Assessment Report Section 4.55(1A) Modification

**SSD 7348 Modification 6
2 Aldington Road, Kemps Creek**

**Prepared for Goodman Property Services (Aust.) Pty Ltd
Submitted to Department of Planning, Industry, and
Environment**

February 2021

Figure 1: Approved (as modified) Masterplan Layout (Source: SBA Architects)

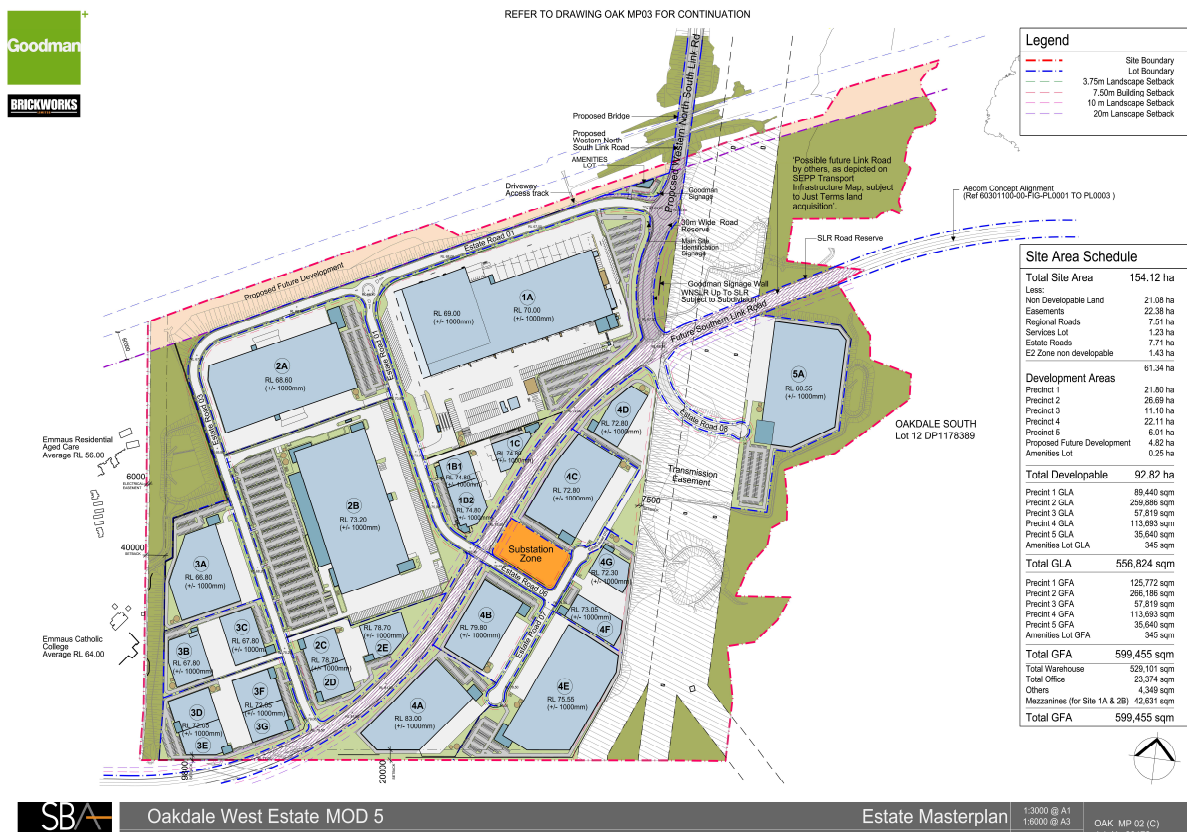
- Concept layout of 22 warehouse buildings inclusive of dock offices and ancillary offices providing 476,000 square metres (m²) of gross lettable area (GLA), built over five development stages (Figure 1)
- Concept layout of development lots, internal roads, drainage, landscaping, noise walls, basins and biodiversity offsets
- Development controls including building height, setbacks, lot size, and site coverage.

Figure 3: Stage 1 DA layout changes (Source: SBA Architects)

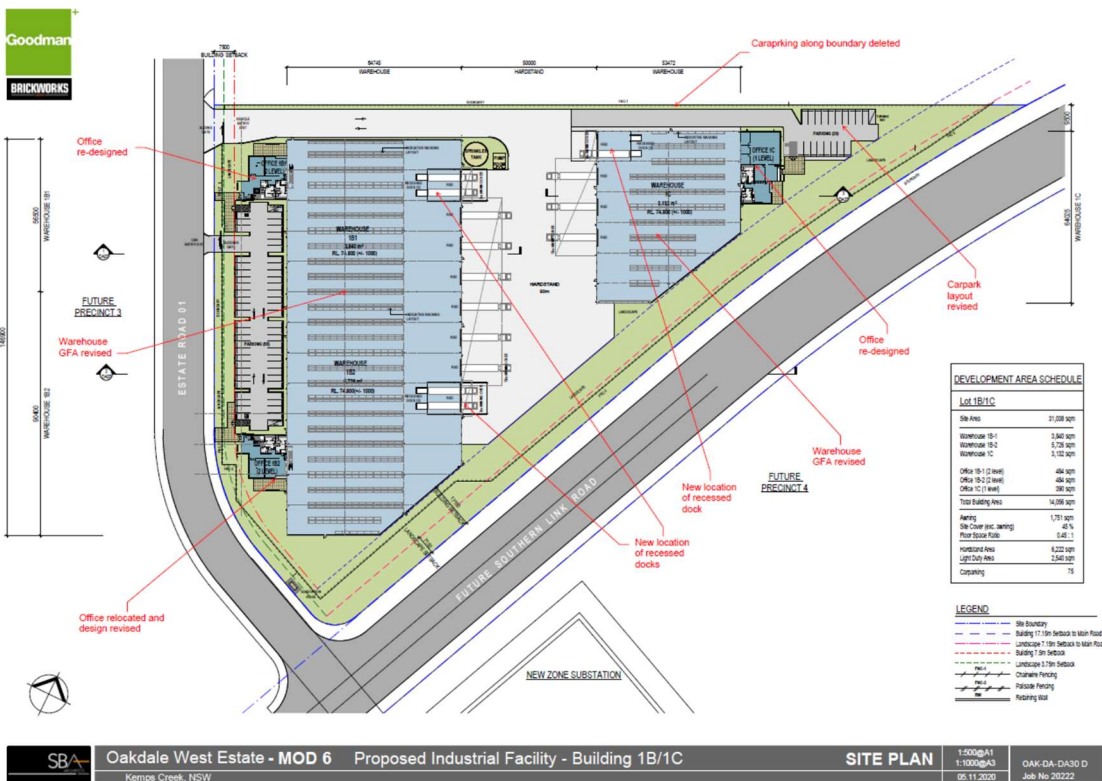
- Construction of Estate Road 8 in its approved alignment under the Concept Plan Approval, as part of the Stage 1 works
- Minor architectural changes to buildings 1B and 1C (see Table 3 and Figure 3)
- Changes to area identified for offsetting in Vegetation Management Plan

Element	Approved (as modified)	Proposed	Change
Warehouse 1B-1 area	3,854 m ²	3,840 m ²	-14 m ²
Warehouse 1B-2 area	5,686 m ²	5,726 m ²	+40 m ²
Warehouse 1C area	3,586 m ²	3,132 m ²	-454 m ²
Office 1B-1 area	500 m ²	484 m ²	-16 m ²
Office 1B-2 area	569 m ²	484 m ²	-85 m ²
Office 1C area	436 m ²	390 m ²	-46 m ²
TOTAL	14,631 m²	14,096 m²	-535 m²
Awning	1,400 m ²	1,751 m ²	+351 m ²
Site cover	47%	44%	-3%
FSR	0.47:1	0.44:1	-0.03
Hardstand area	6,445 m ²	6,222 m ²	-223 m ²
Light duty area	2,365 m ²	2,540 m ²	+175 m ²
Carparking spaces	83	75	-8

The proposed changes to Buildings 1B and 1C (Table 3 and Figure 3) comprise minor revisions to the layout and GFA of offices and carparking, revised locations of recessed docks and amended water tank and pump layout. The layout and scale of these warehouse buildings is generally consistent with the approved Stage 1 layout and there are no proposed changes to setbacks, building heights or access.

Figure 1 Estate Masterplan (Mod 6)

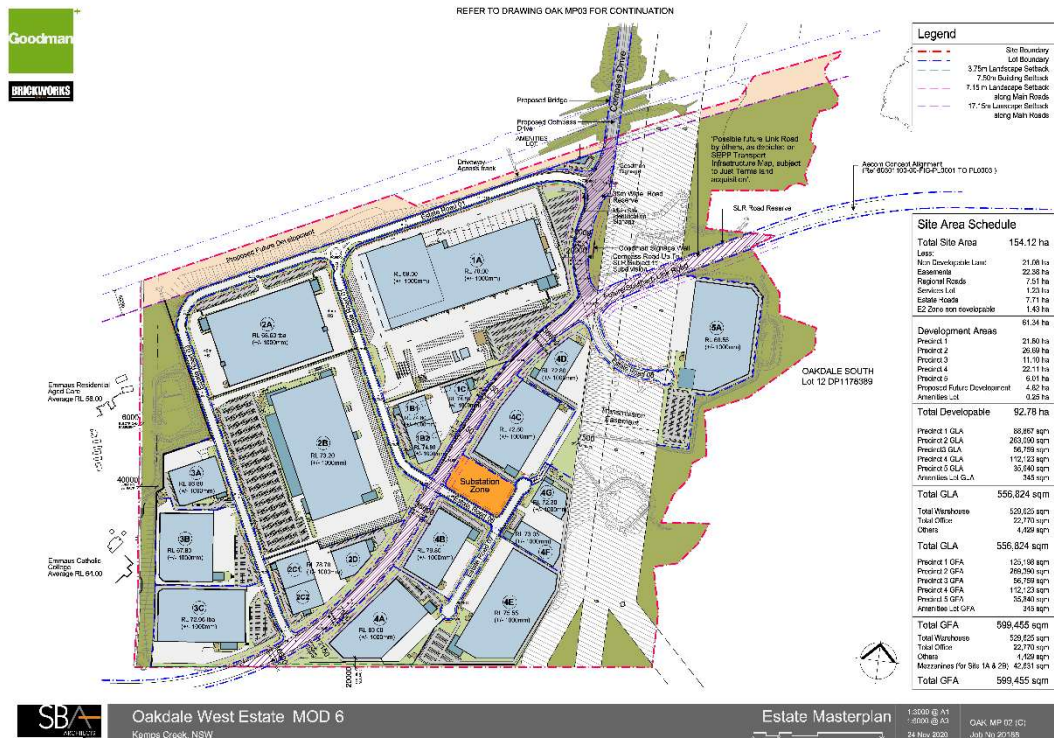
Delete Figure 1 and replace with the following:

Figure 2 Staging plan (Mod 6)

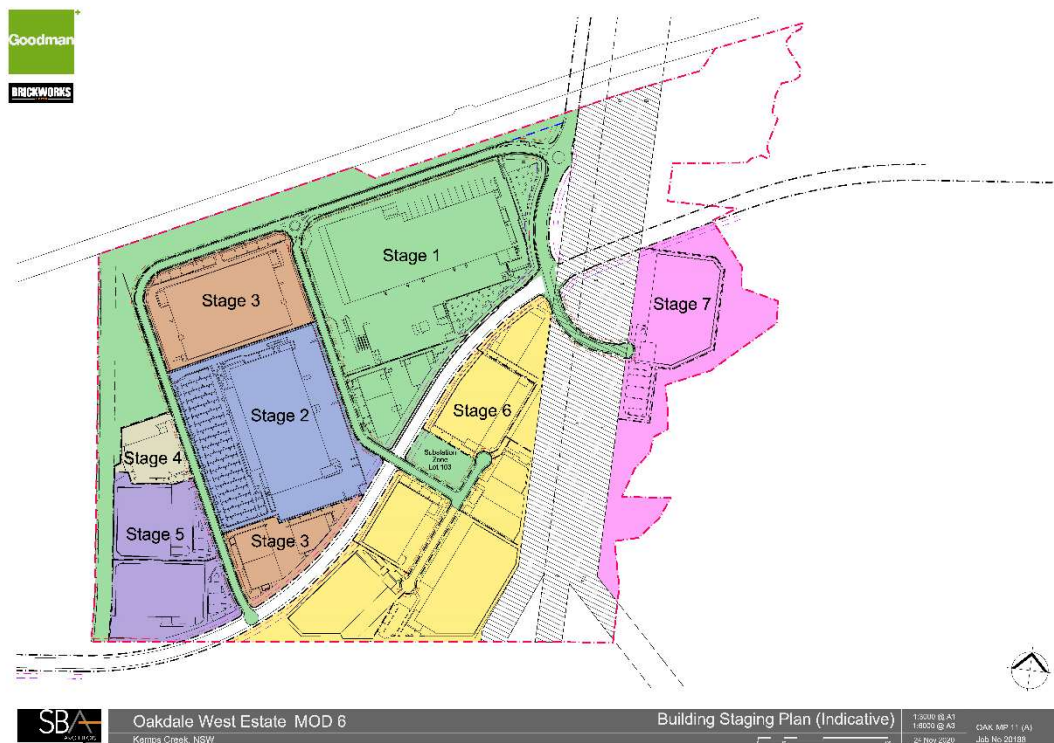
Delete Figure 2 and replace with the following:

Figure 6: Photomontage view from Emmaus Catholic College showing proposed Building 2A (Source: Clouston Associates)

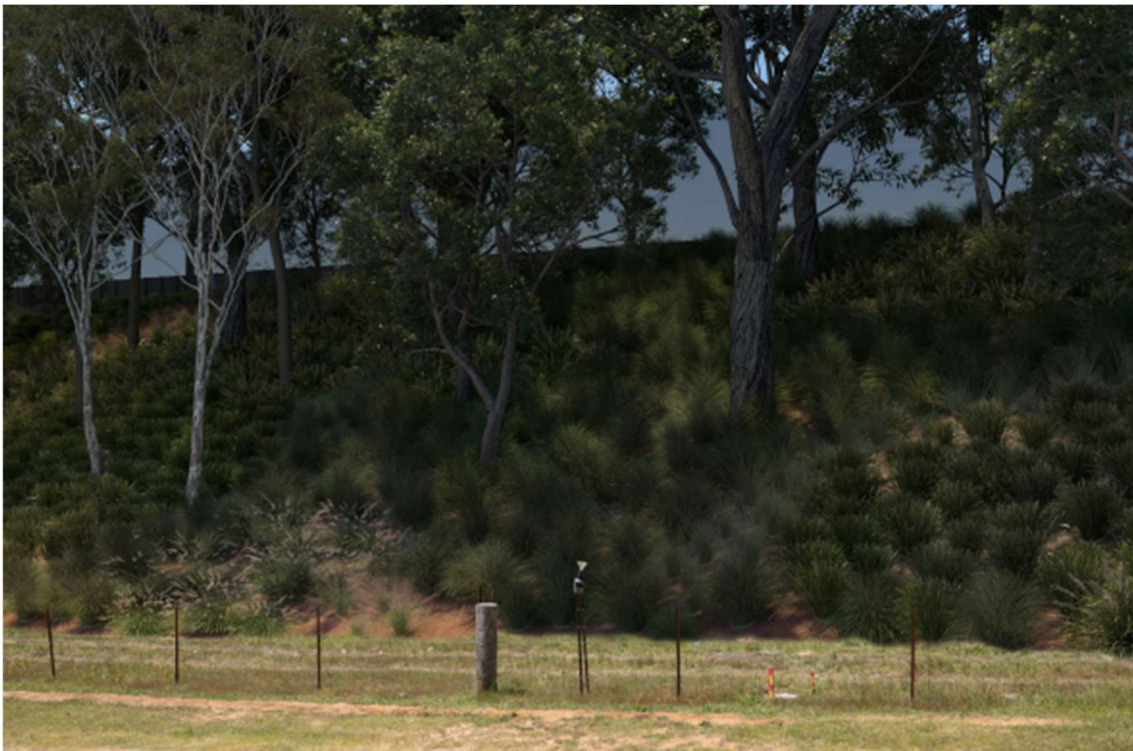
The modification proposes to increase the maximum height envelope of Building 2A from 15 m to 18 m, with the maximum approved ridge height to be increased from 13.7 m to 14.9 m. The proposed height increase is required to enable installation of rooftop plant, solar panels and equipment.

A memorandum regarding visual impacts, prepared by Clouston Associates, is included with this report (Appendix 8). The memorandum confirms that given the minimal 1.2m increase in height of Building 2A, the visual impact rating of the building does not change. In particular, the sensitive receivers to the west will not be further impacted as demonstrated in the photomontages provided by Clouston Associated (Figure 5 and Figure 6).
